**From:** Johns, Renee  
**Sent:** Thursday, March 1, 2018 3:41:33 PM  
**To:** Thompson, Jeffrey - BC; Olsen, Dillon  
**Subject:** RE: [1401 E 3rd Street](#)

Public Comment Re: Case Number C15-2020-0020 (1401 East 3<sup>rd</sup> St.)

SINGLE-FAMILY RESIDENCE W/  
ACCESSORY APT AT  
1401 E 3RD ST  
AUSTIN, TEXAS 78702

1 Site Plan  
Scale 1/16" = 1'-0" @ 11x17  
Scale 1/8" = 1'-0" @ 24x36

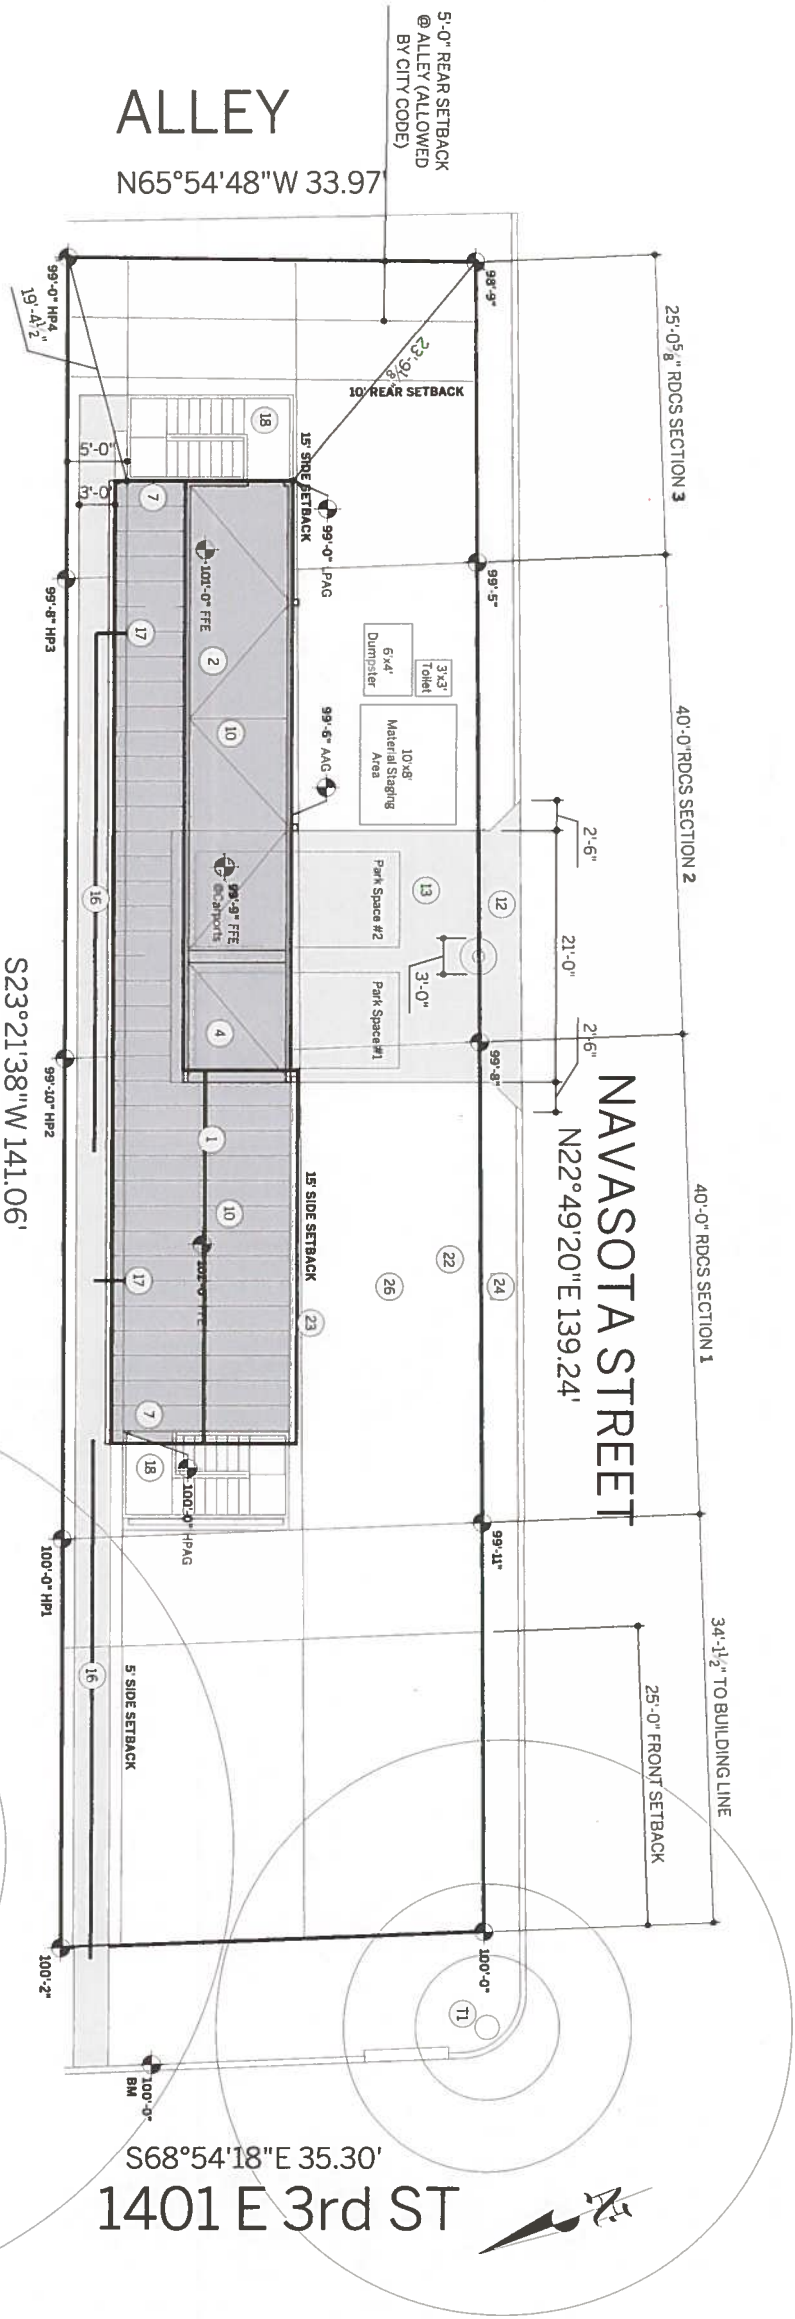
I'm looking into a case on behalf of a district 3 constituent. She is concerned that the house being built at 1401 E 3rd does not have a 5 foot side setback.

Looking at the plan (2017-043148 PR), it clearly shows that the house encroaches on the 5 foot set back line. Can you tell me if this is in fact an approved plan and if so can you please explain why?

1401 E 3rd St is requesting a variance on the interior setback from 5 to 2.77 feet. I own the property adjacent at 1403 E 3rd St.

I am **against** granting this variance. I have been extremely concerned about this as it puts the neighboring property way too close to my own and will devalue my property and privacy.

The site plan (attached) confirmed that the plan was approved in violation of the code, but no immediate justification was apparent. Once the foundation was poured in violation of the code, I sent another inquiry. The response by City staff to this inquiry was dismissive, despite the clear violation and

This is an approved plan and there is a projection into the 5 foot setback. This is a common concern, but the code does allow for eaves and other incidentals to project 2 ft. into any setback, LDC 25-2-513 B. If you look at sheet A201, you can see the elevation view of the proposed residence. On this elevation, you can see the footprint of the building stops at the 5 ft. setback and the eaves project into the setback. Again this is an allowed and common design.
